DEVELOPMENT NO.:	23009117
APPLICANT:	Scott Salisbury Homes
ADDRESS:	6 HAMILTON ST SOMERTON PARK SA 5044
NATURE OF DEVELOPMENT:	2 x two-storey detached dwellings with swimming pools and associated fencing and retaining walls
ZONING INFORMATION:	Zones: <ul style="list-style-type: none"> • General Neighbourhood Overlays: <ul style="list-style-type: none"> • Airport Building Heights (Regulated) • Affordable Housing • Building Near Airfields • Hazards (Flooding - General) • Prescribed Wells Area • Regulated and Significant Tree • Stormwater Management • Urban Tree Canopy
LODGEMENT DATE:	3 Apr 2023
RELEVANT AUTHORITY:	Assessment Panel at City of Holdfast Bay
PLANNING & DESIGN CODE VERSION:	2023.5
CATEGORY OF DEVELOPMENT:	Code Assessed - Performance Assessed
NOTIFICATION:	Yes
RECOMMENDING OFFICER:	Alexander Stamatopoulos Development Planner
REFERRALS STATUTORY:	Nil
REFERRALS NON-STATUTORY:	Nil

23009117 – Response to Representations

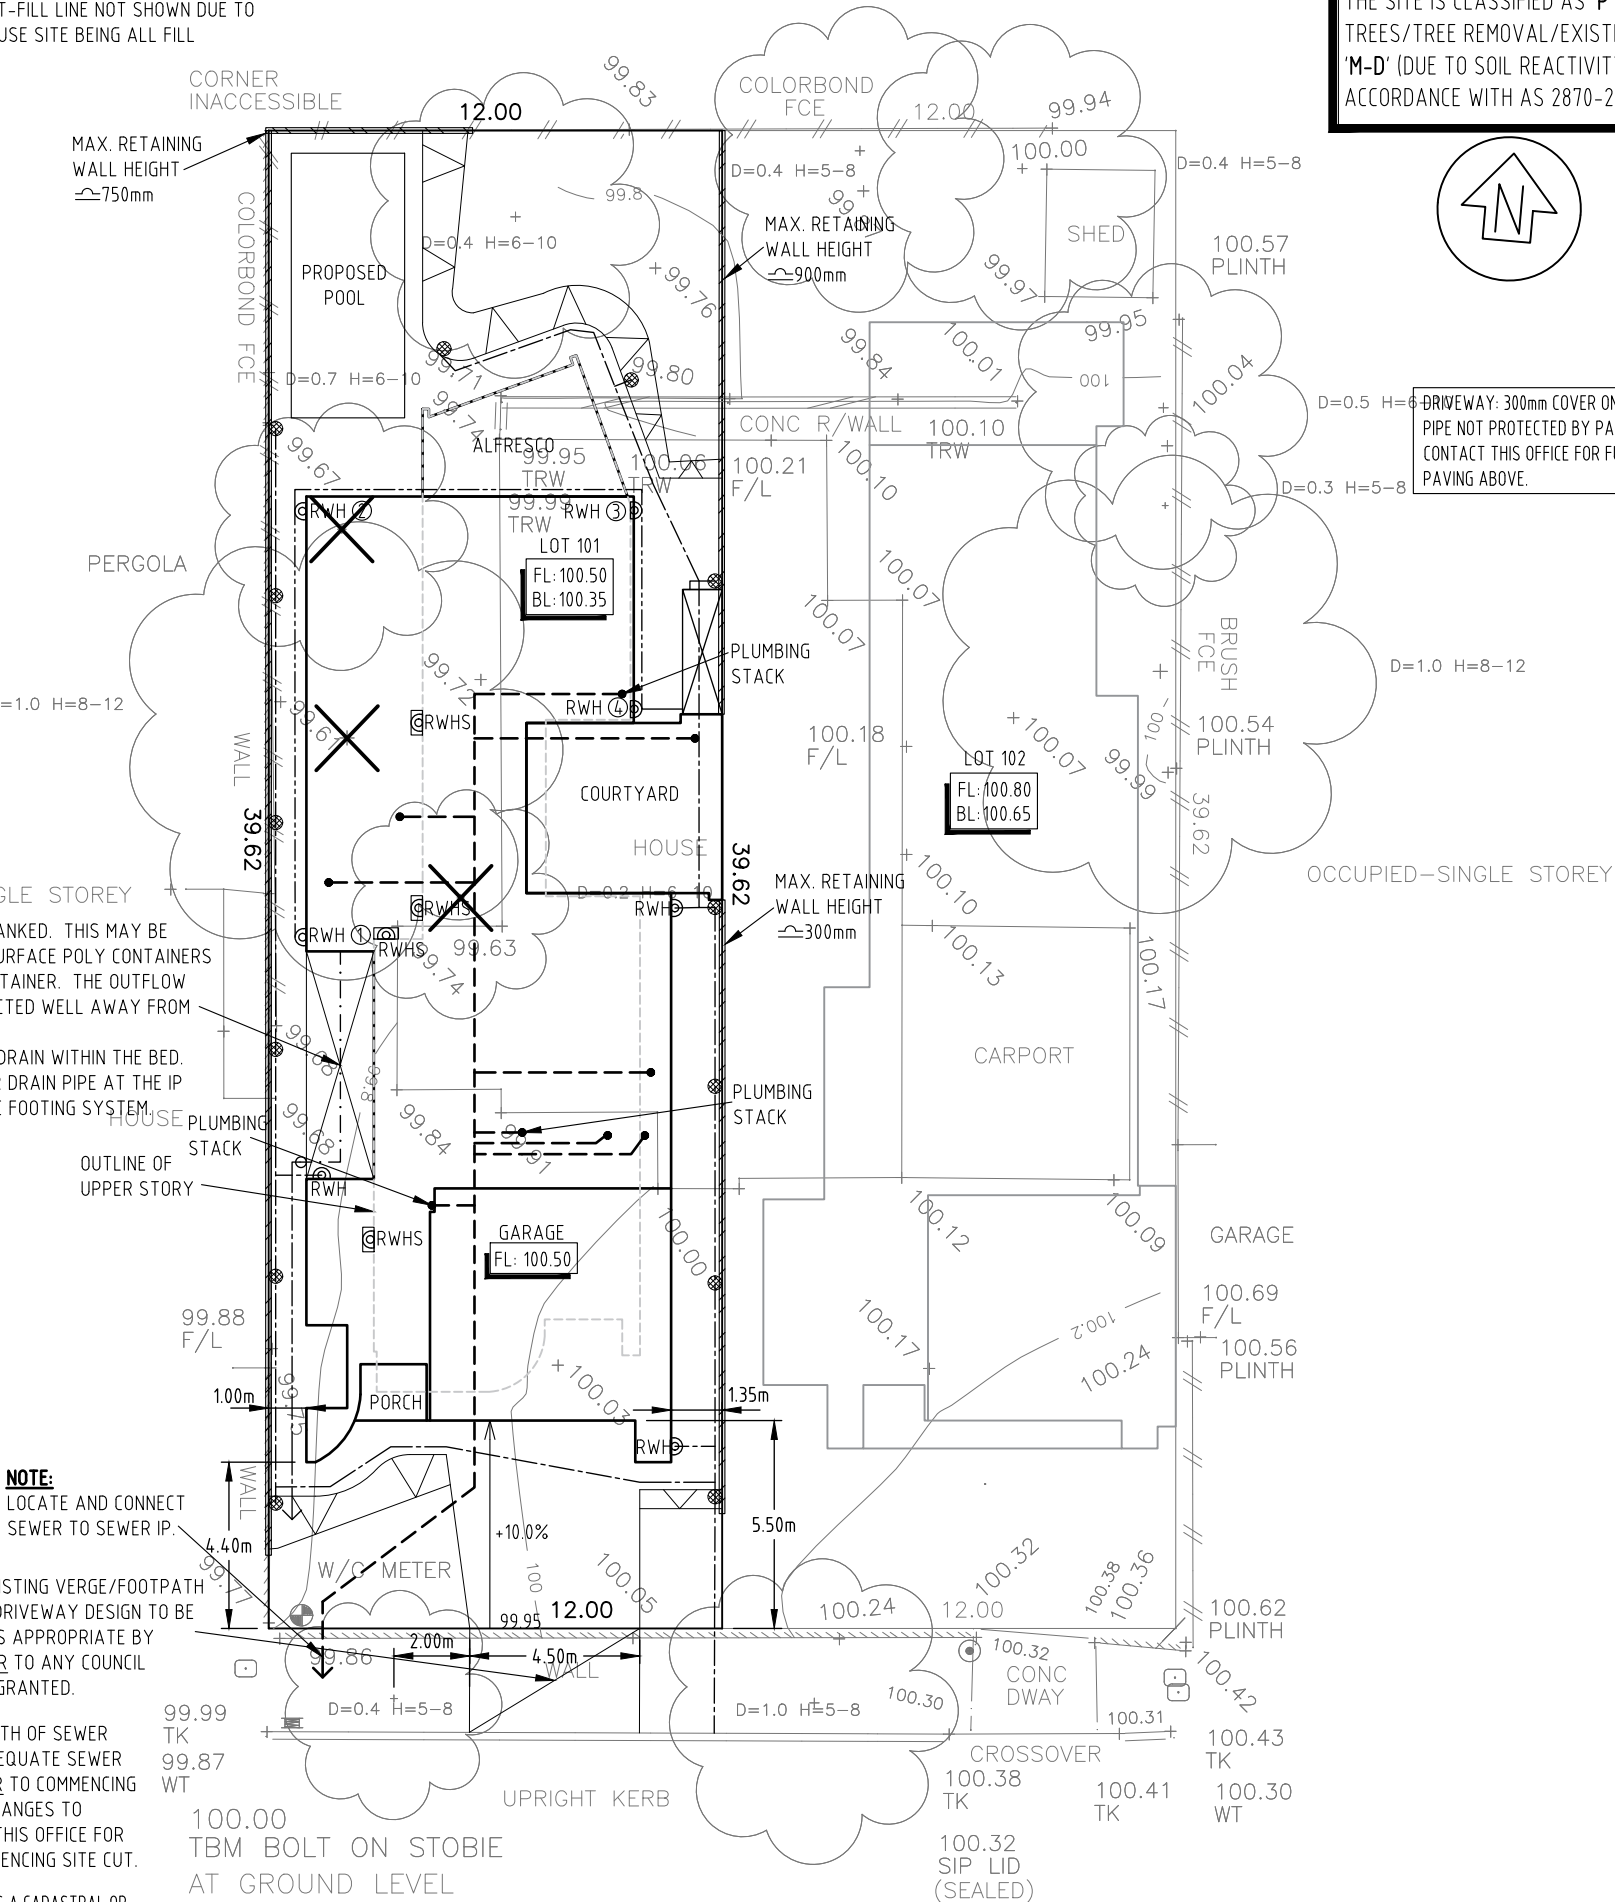
The site works plan shows the existing ground levels and finished floor level of the dwellings. The site will be subject to fill up to 700mm from the existing ground level toward the rear of the land. The relevant assessment provisions relating to earthworks is shown below:

Home 1 site plan indicates the pool level apron 700mm above natural ground. Then the eastern side of the lot batters down to ground level. This seems odd but I have concern if this is the case. I would end up with a 6 foot fence on top of a 2 foot retaining wall for half of my rear view, then just a 6 foot fence for the remainder. Surely this is not the outcome desired. I am concerned at an 8 foot barrier, this is excessive but at least it must all be at the same height. I could see no details of the fence colour, but hope that will all be revealed in the fencing notice. I have no concerns with the house as proposed.

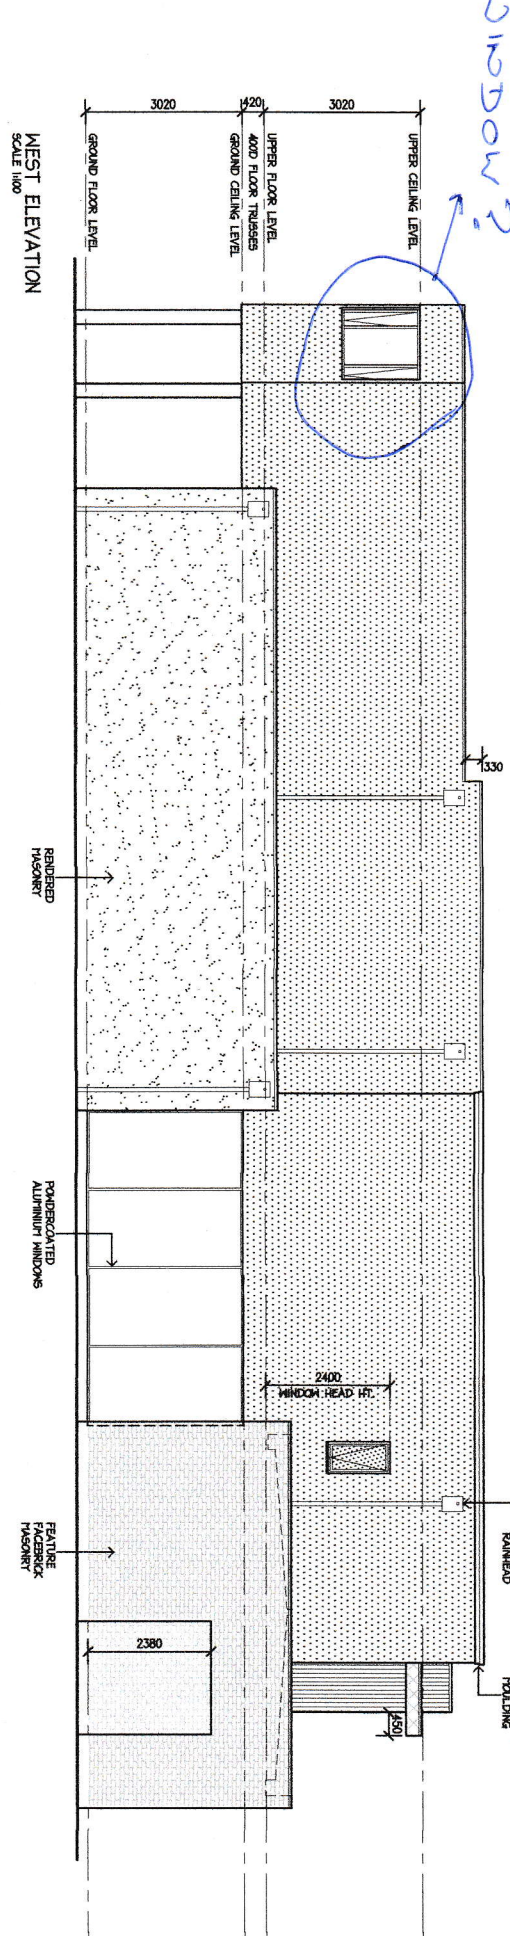
It appears that there is an upstairs window facing West and overlooking my swimming pool, kitchen, family room and outside alfresco area. If this window is in the plans, then I strongly disagree with the incorporation of this window. I also have an irrigation hose on my eastern side outside my garage and on my property to feed water to a garden bed inside my driveway. This needs to remain and I don't mind if it is covered over.
